Flight Procedures Cover Page	Task Action: FLIGHT CHECK	Task Type: STAR	Estimated Chart Date: 12/02/2021	APWS Task ID: 7CC290C0445149128F4D79C6C92FC926	APWS Project ID: 00EA277574244D34876FE47814BE4494
Procedure: DADES EIGHT (RNAV) STAR		Enroute: YES	Specialist: Dumar, Ralph		Agreement Number:
Airport ID: KTPA			Airport City: TAMPA		State: FL
Facility ID:	Facility Type:	Flight Inspection Remark Type: New FC Slot

<b>FIPC DME/DME FORM</b>								
<b>PROCEDURE:</b> DADES EIGHT (RNAV) STAR			<b>AIRPORT NAME:</b> TAMPA INTL		<b>AIRPORT ID:</b> KTPA	<b>SPECIAL CONTROL NO:</b> AG-08-187-21		
<b>FAC ID:</b> DADES8		<b>CITY:</b> TAMPA			<b>ST:</b> FL	<b>ORIG CHART DATE:</b> 12/02/2021		
<b>DFL TYPE:</b> PROC/D	<b>THIRD PARTY:</b> <input type="checkbox"/> YES	<b>EST. TIME ON SITE:</b> 1.0	<b>REIMB. NUMBER:</b>		<b>PTS TASK ID:</b>			
<b>PREFLIGHT NOTES</b>								
<b>REVIEWER:</b>					<b>DATE:</b>			
<b>COMMENTS:</b>					<b>CHECK ONE:</b> <input type="checkbox"/> FLT CK REQ <input type="checkbox"/> NFCR <input type="checkbox"/> REJECT			
							<b>YES</b>	<b>NO</b>
					<b>CPV COMPLETE?</b>		<b>X</b>	
<b>PROCEDURE RESULTS</b>								
<b>INSPECTION DATE:</b> 09/22/2021		<b>CREW #:</b> VN472	<

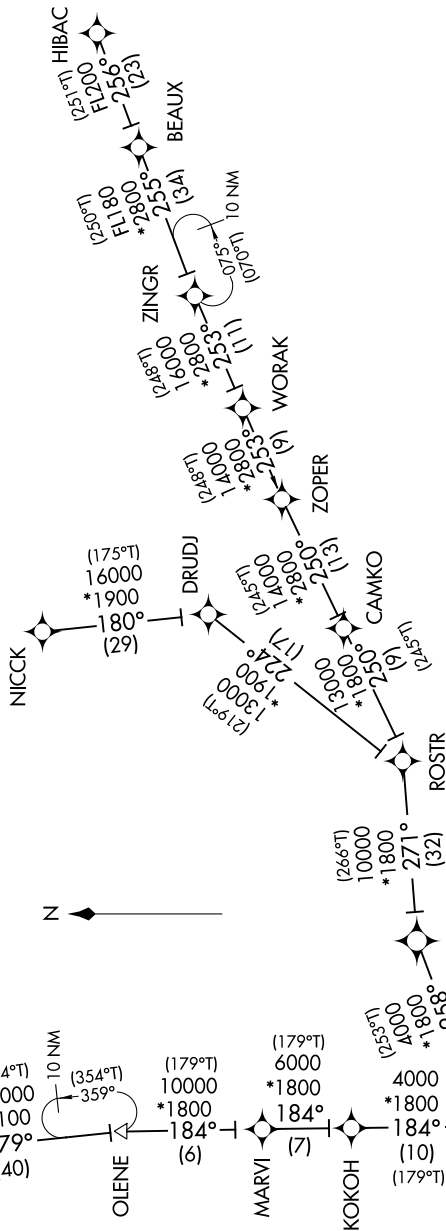
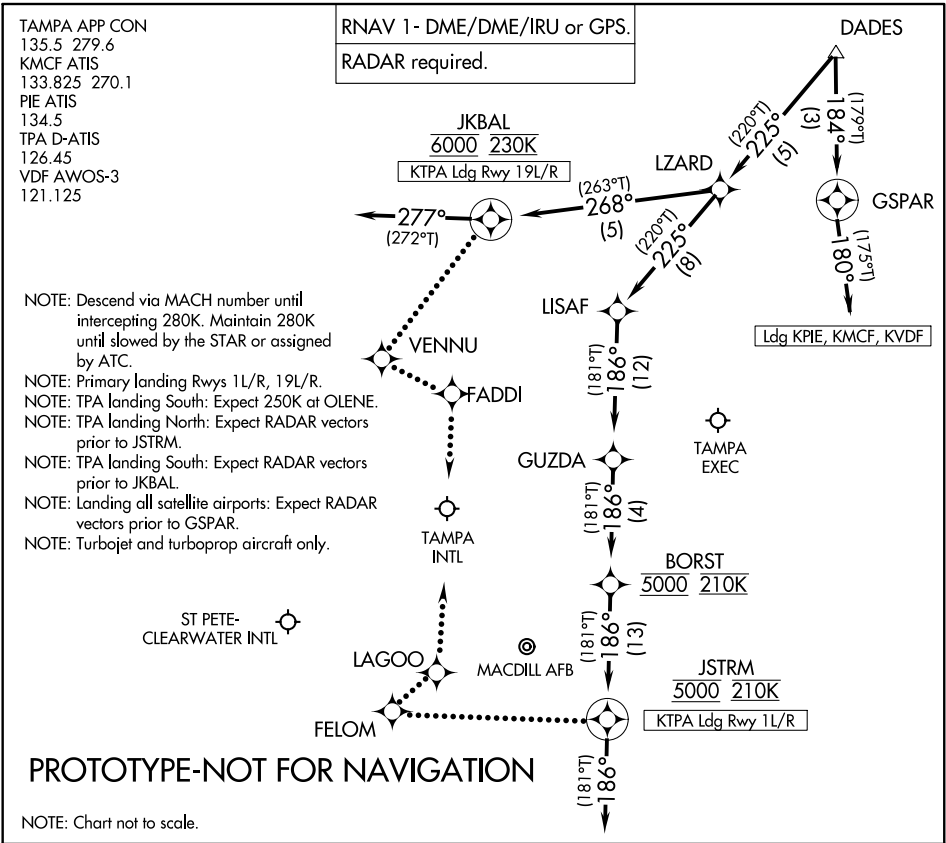
09/29/21: THIS IS AN UPDATED COPY OF THE FORM DEVELOPED ON 05/18/21.  
 1. REMOVED NOTE: NOTE: TPA Landing South: Expect 250KIAS at OLENE - AFS RECOMMENDATION.  
 2. REMOVED NOTE: Descend via MACH number until intercepting 280K. Maintain 280K until slowed by the STAR or assigned by ATC - ATC REQUEST.

10/08/21: THIS IS AN UPDATED COPY OF THE FORM DEVELOPED ON 05/18/21.  
 REMOVED REMARK "DO NOT CHART MOCA: HIBAC TO BEAUX" -MOCA REQUIRED

**FORTL EIGHT STAR: NAR (DEC PUB IS FORTL NINE)**

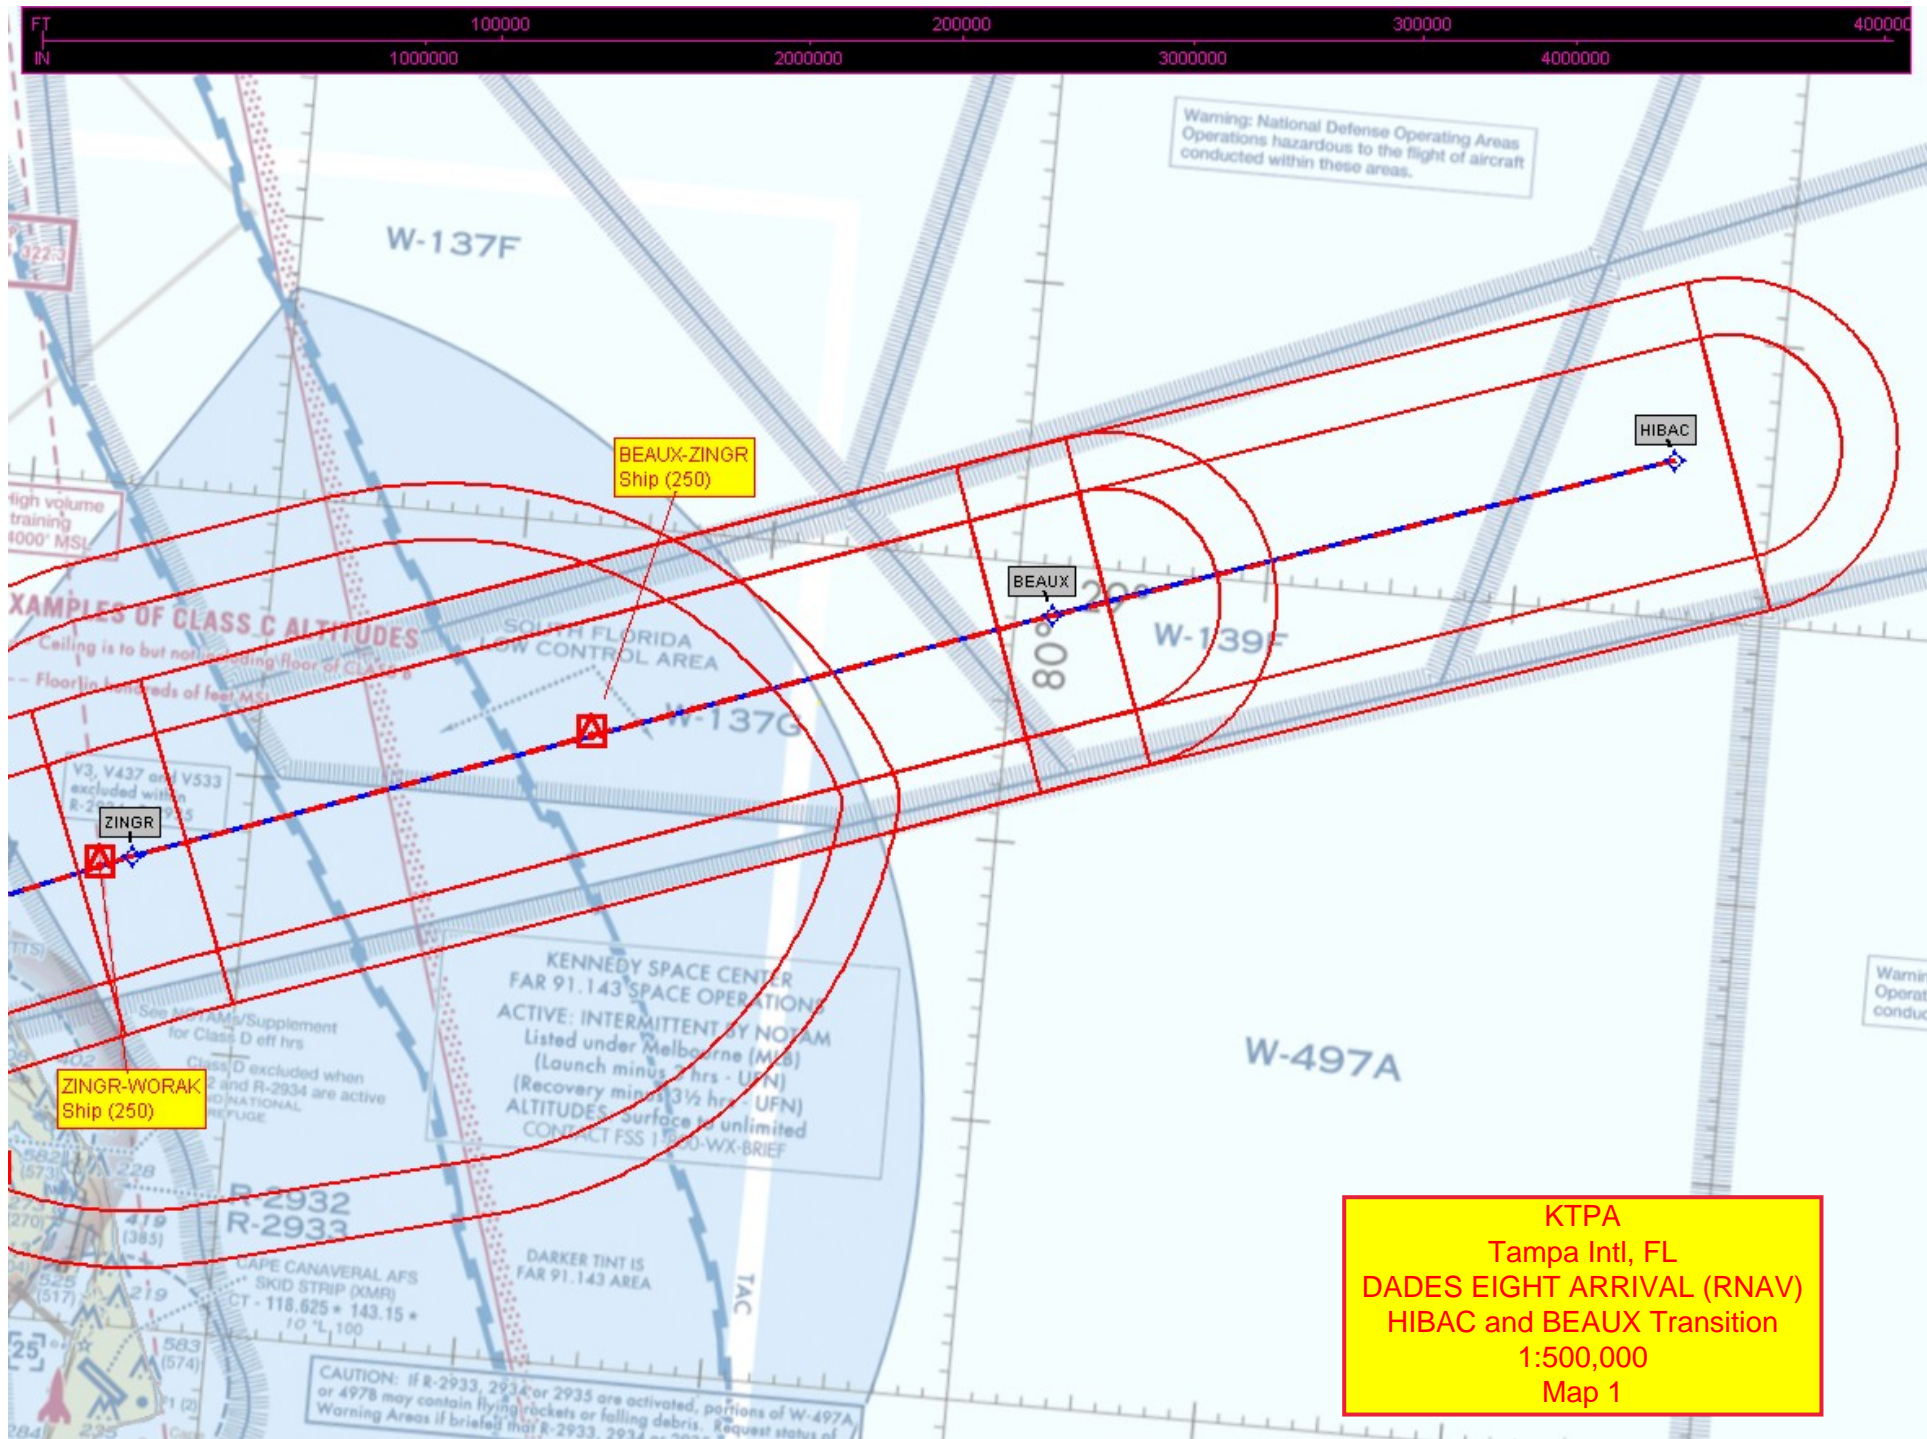
1. Do not raise MEAs for ATC operational needs: V7 from RSW to FORTL MEA is 2300. The procedure shows 10000. Why is the MEA 10000?

I am sure there are several reasons (this has been unchanged since before FORTL 7)...a couple that stick right out are the fact that the DG is 411 if utilizing 2300 and the fact that most IAP'S in the region start anywhere between 2700-5000 (A/C would have to climb to reach feeder/IAF).

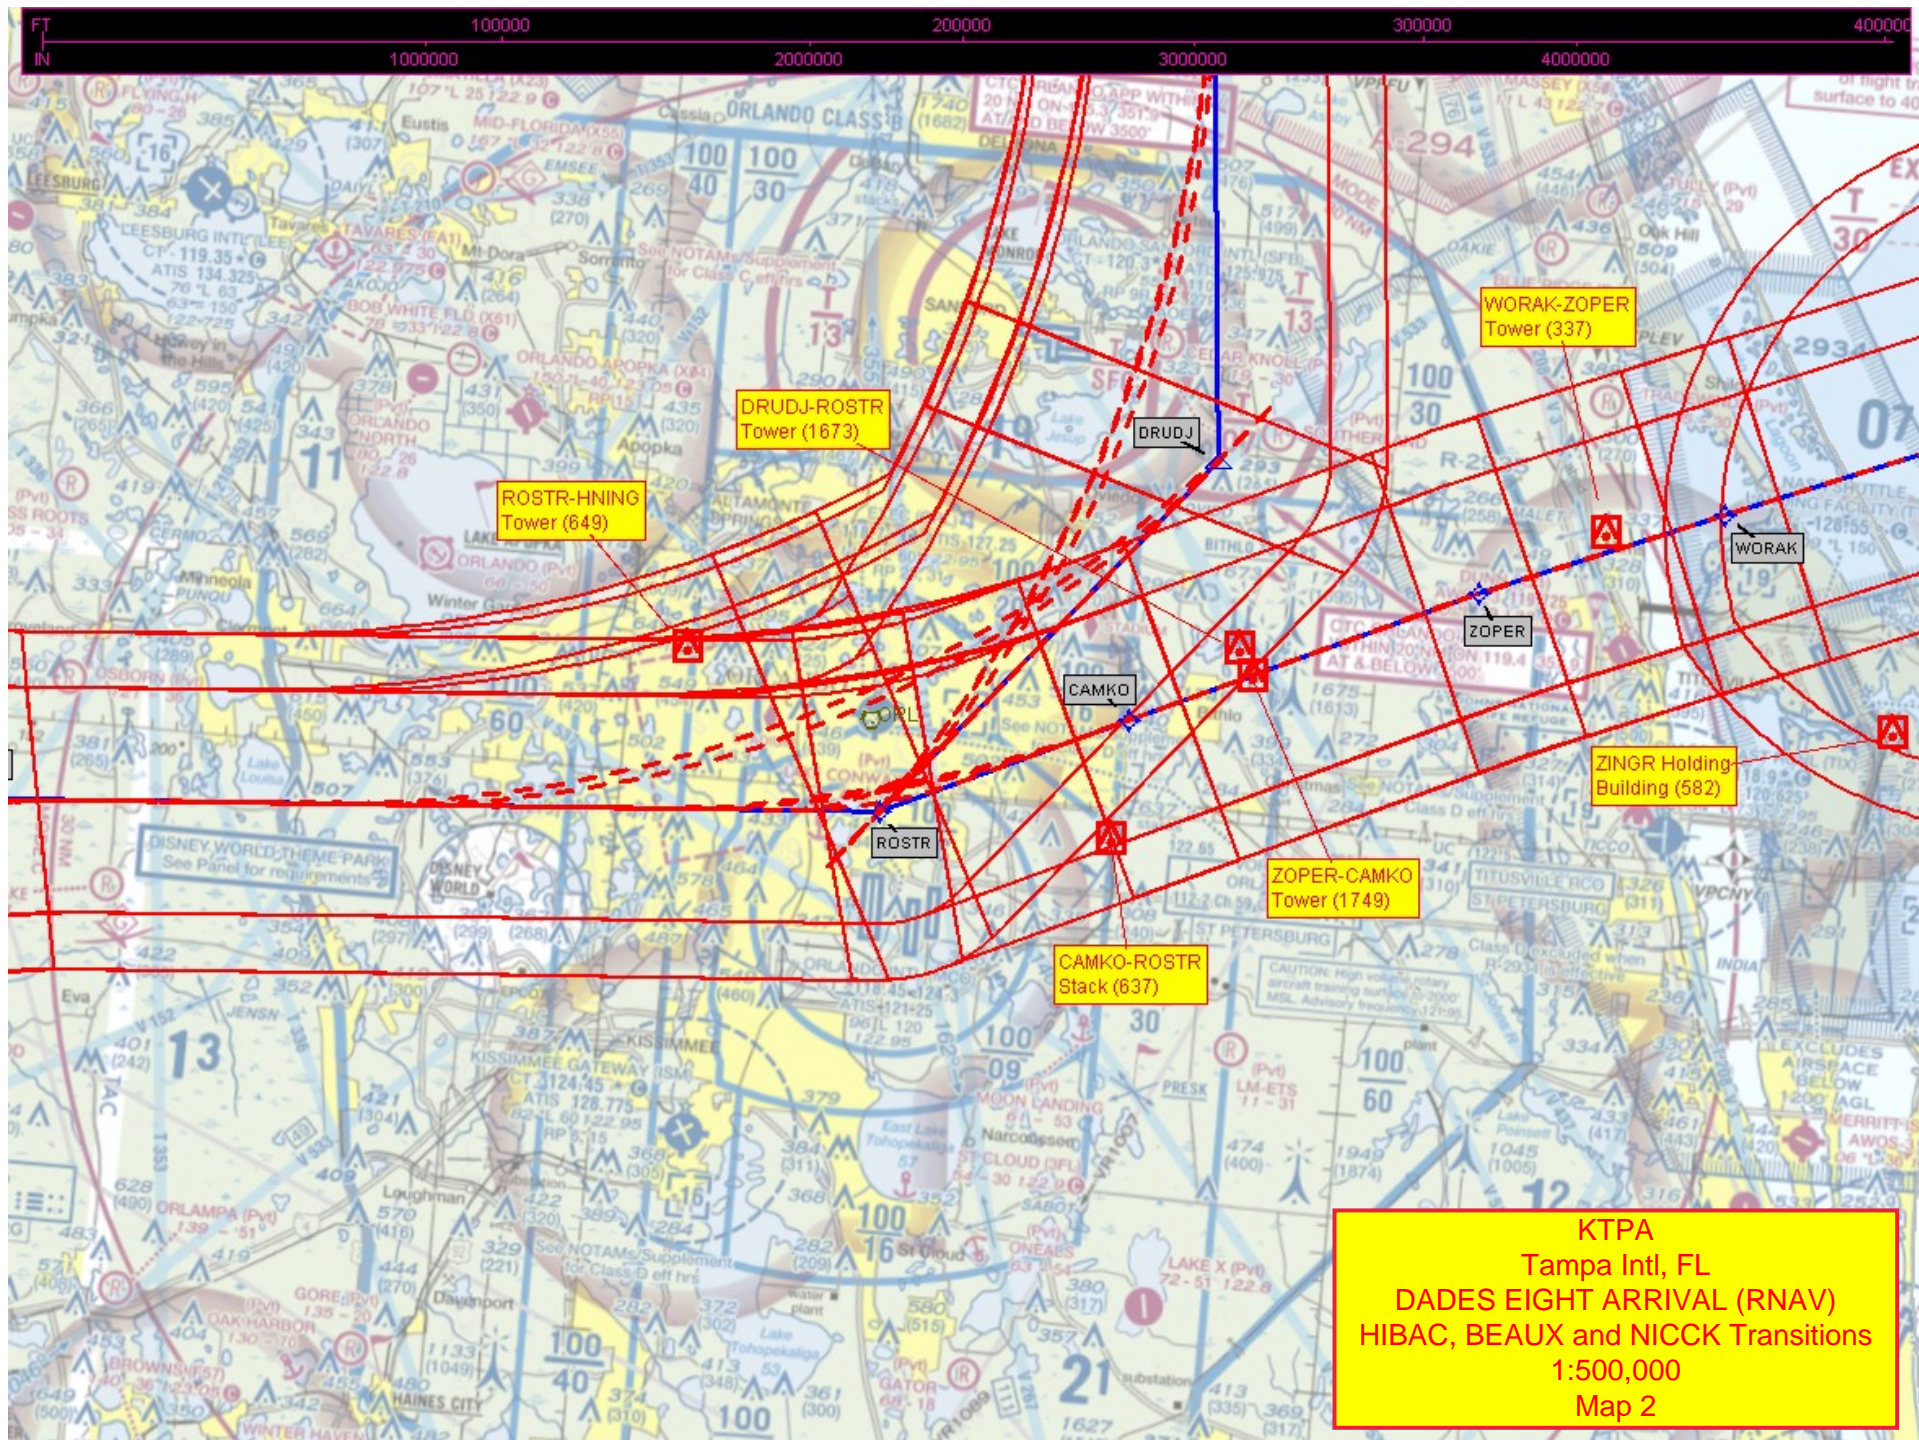
2. Delete V7 between FORTL and CHICK: FORTL to CHICK is not part of V7 since CHICK is not on V7.

**Charting notified**
